## Access Compliance Report Public Rights-of-Way (Curb Ramps)

Intersection ID: 16439Main Street:SOUTH\_BVCross Street:SCALEYBARK\_RDLocation:NWADA ID: 5987D6ADCDCARamp Type:ParaInitial Pass/Fail:FailOverall Compliance:NoSeverity Score:25

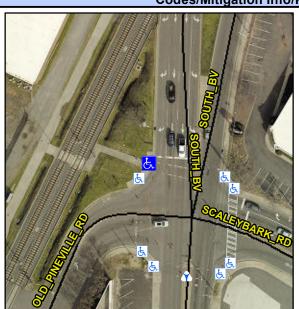
PROW/ADA:

R304.5.3

Field Measurements/Component Compilance						
Comp	liance Description	Data	Comp	liance Description	Data	
N/A	Ramp Length LT (in)	60.0	N/A	Ramp Length RT (in)	64.0	
Yes	Ramp Width LT (in)	72.0	Yes	Ramp Width RT (in)	71.0	
Yes	Ramp Slope LT (%)	5.5	Yes	Ramp Slope RT (%)	6.2	
Yes	Ramp XSlope LT (%)	1.7	No	Ramp XSlope RT (%)	7.2	
N/A	Landing Length (in)	N/A	N/A	DWS Provided?	N/A	
N/A	Landing Width (in)	N/A	N/A	DWS Contrast?	N/A	
N/A	Landing Slope (%)	N/A	N/A	DWS Length (in)	N/A	
N/A	Landing X Slope (%)	N/A	N/A	DWS Full Width?	N/A	
N/A	Landing Curb? (Y/N)	N/A	N/A	DWS Offset (in)	N/A	
N/A	Shared Landing?	N/A				
N/A	Gutter Ponding?	N/A	N/A	Gutter Slope (%)	N/A	
N/A	Gutter Lip Ht (in)	N/A	N/A	Gutter X Slope (%)	N/A	
N/A	Painted X Walk1?	Yes	N/A	Painted X Walk2?	N/A	
	X Walk 1 Direction	То Е		X Walk 2 Direction	N/A	
N/A	X Walk 1 Width (in)	116.0	N/A	X Walk 2 Width (in)	N/A	
	X Walk 1 Slope (%)	3.3		X Walk 2 Slope (%)	N/A

Possible Solutions:

Remove & Replace Entire Ramp.
